From: [Piu Ghosh \(she/her\) \(Cupertino Planning Department\)](#)
To: [Lindsay Nelson](#)
Subject: Fwd: City General Plan Feedback-Health and Safety Element of the General Plan
Date: Monday, March 9, 2026 5:24:36 PM

From: Kitty Moore <ckittymoore@gmail.com>
Sent: Sunday, March 8, 2026 8:13 PM
To: City Clerk <cityclerk@cupertino.org>; lsapuder@cupertino.gov
Subject: Written Communications PC Meeting Cupertino Health and Safety Element Item 2 and Include as Comments to the Draft

To: Cupertino Planning Department
From: Steve Hill, Cupertino resident
Subject: Feedback on the Draft Health and Safety Element
Date March 10, 2026

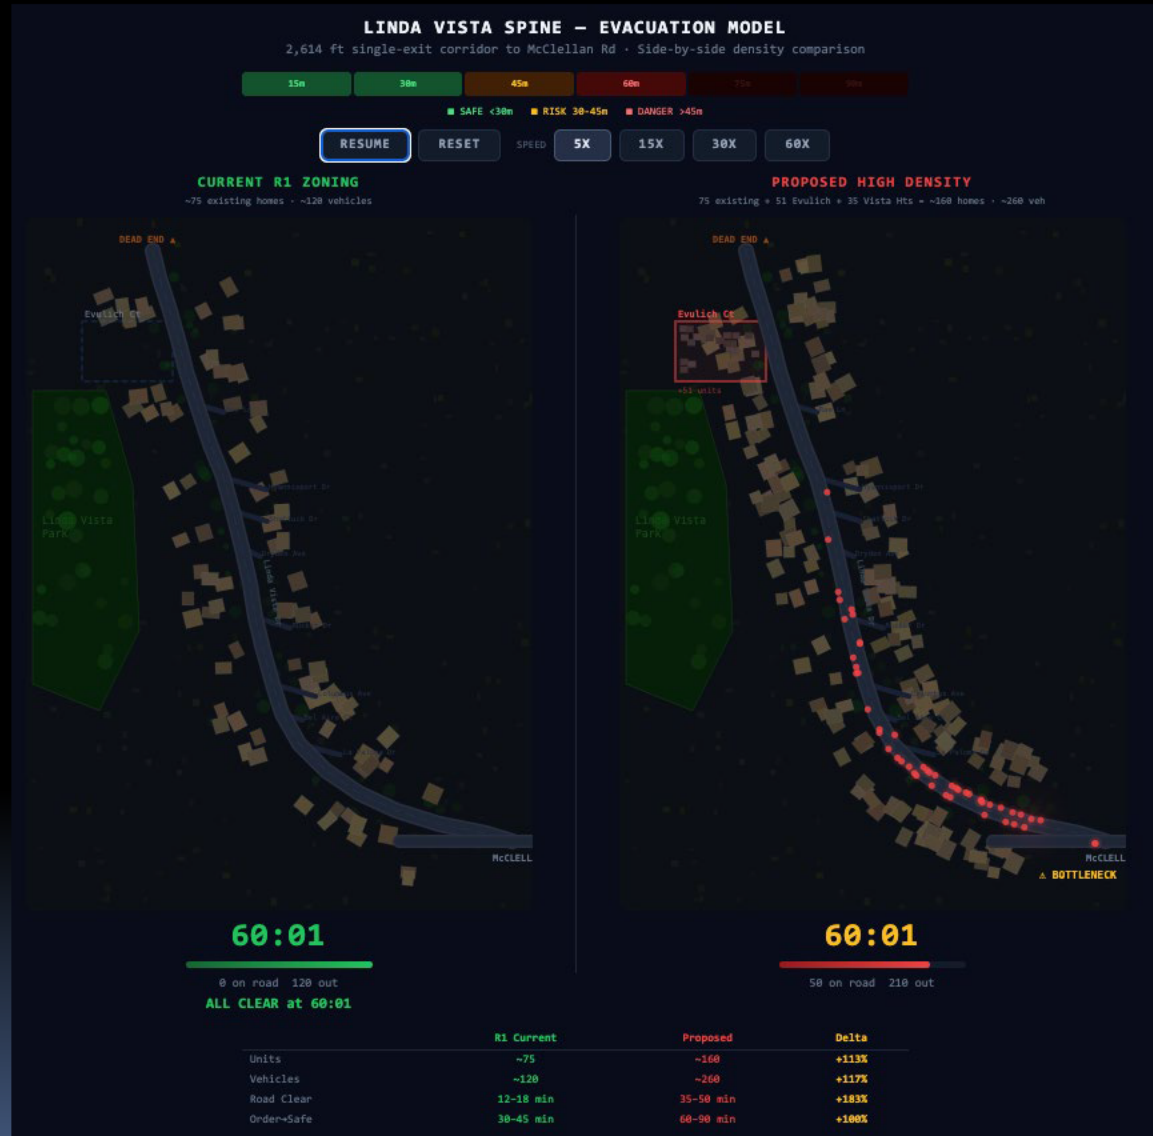
High-Risk Zones Require Street-Level Modeling

Four evacuation zones lie within Fire Hazard Severity Zones, yet the City has not modeled their street-level evacuation behavior.

- All designated evacuation routes lie outside FHSZ
- But CUP016, CUP017, CUP029, CUP032 lie inside Moderate–Very High FHSZ
 - CUP029 alone = 38% of all evacuation trips
 - McClellan Road V/C = 4.2; Foothill Blvd V/C = 4.0
 - These are not “constraints” —they are system failures
- City must adopt:
 - Street-level DTA, Real-time traffic management, Phased evacuation strategies for FHSZ zone

Thousands of residents remain exposed until Cupertino models evacuation where the risk actually exists.
